ALERT SERVICE BULLETIN

206L-08-150

Revision B, 25 July 2018

SUBJECT: POWER TURBINE RPM (N2) STEADY STATE OPERATION AVOIDANCE, INTRODUCTION OF.

Figure 1 - Typical 206L Instrument Panel Layout
(May vary depending on model and serial number applicability)

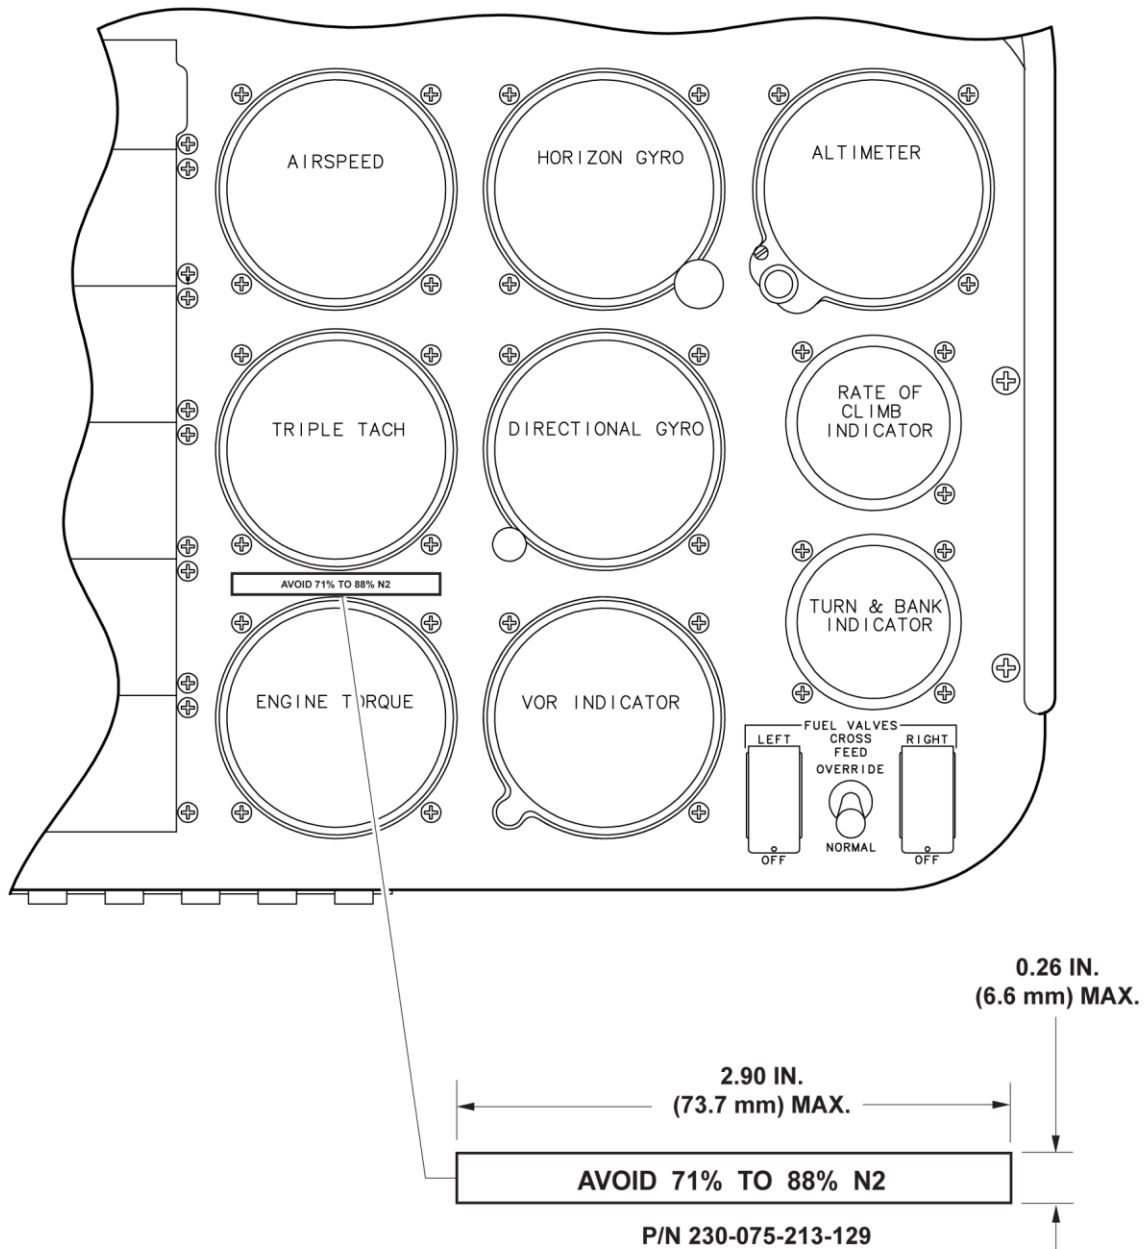
Revision B is a complete reissue of this Alert Service Bulletin (ASB). Rolls-Royce Corporation has revised the maximum allowable output shaft speeds for Series II engines (250-C20R). The new tables have been revised to include the power turbine RPM (N2) speed avoid range between 71% and 88%. Refer to Rolls-Royce ALERT CEB A-72-4095 Revision 6 dated April 12, 2018. **Revision B** of this bulletin provides the instructions to install the new decal 230-075-213-129 to affected helicopters.

1. Prepare helicopter for maintenance.
2. Remove existing 230-075-213-127 decal from instrument panel. Clean the area with aliphatic naphtha (C-305) (BHT-ALL-SPM, Chapter 8).
3. Install 230-075-213-129 decal on the instrument panel below the Nr/N2 RPM dual tachometer indicator. Apply edge sealer (C-349) over the installed decal (BHT-ALL-SPM, Chapter 8).

NOTE 1: The decal may be locally manufactured using lettering of white color (No. 17875) on black background color (No. 17038). Characters to be 10 point Spartan Blackfont and color per FED STD 595. The text for the decal is detailed in Figure 1 and should be in capital letters.
